SERVICE LETTER

No. 751

Piper Aircraft Corporation

Fin Front Spar Modification.

SPAR TRIMMING DETAIL

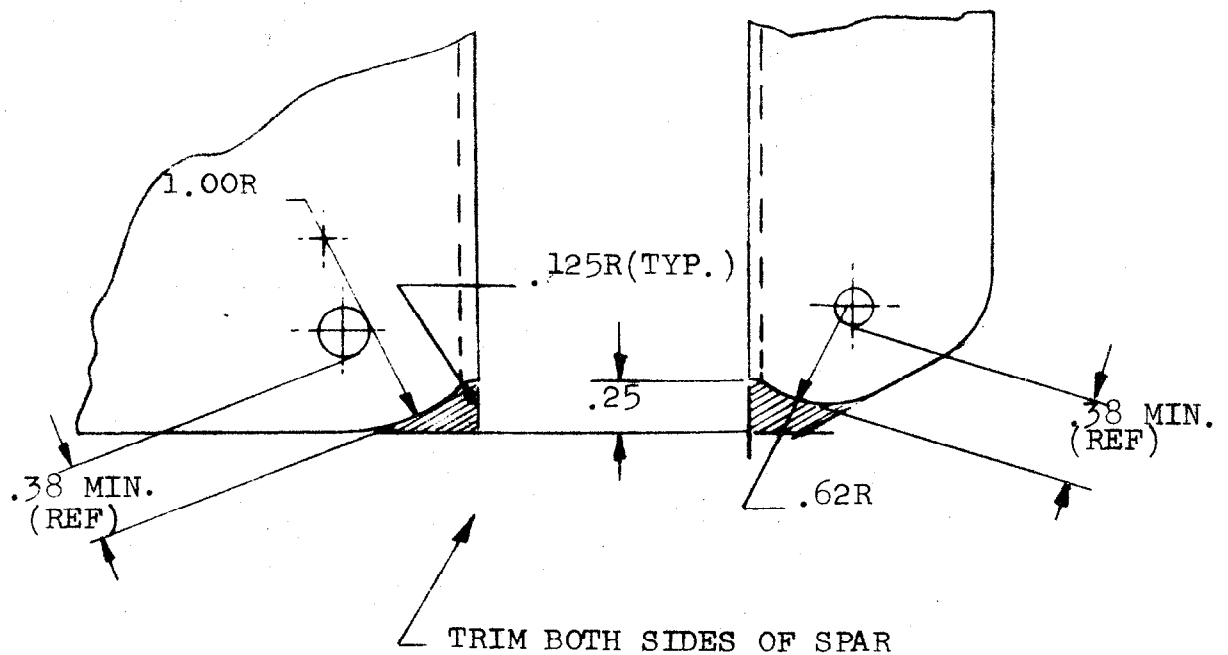
Currently, it is necessary to physically remove the fin to gain visual access to the channel relief holes, as the fin front spar extends over the relief holes by approximately 1/2 to 2/3 of the relief hole diameter.

To eliminate removal of the fin and to enable an easy visual inspection, the fin front spar may be modified in accordance with the sketch/instruction sheet contained on the reverse side of this release.

Refer to "Spar Trimming Detail" on reverse side of this release.
